INVENTORY NO. 004

LOCATION: Main Substation

EQUIPMENT: North Cap. Bank Yard
Center Phase Buss-to-Underground Feeder
Connection.

Thermal Infrared Exception Photo

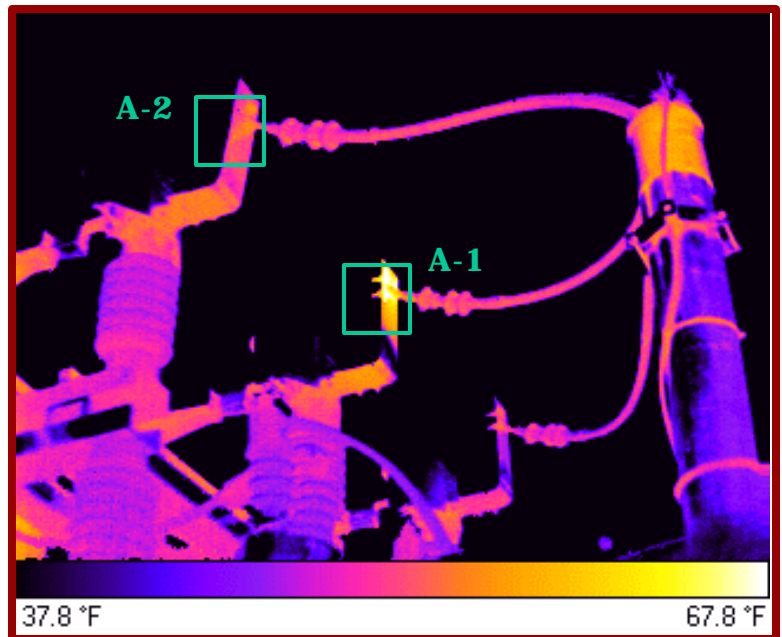
FINDINGS: Suspect loose deteriorated Buss-to-
Underground Feeder Connection

EXCEPTION TEMP. (Area.1): 71F

REFERENCE TEMP. (Area 2): 50F

DELTA-T: 21F

PRIORITY 2

RECOMMENDATIONS: Inspect, clean, and tighten
center phase buss connector and all related
components.
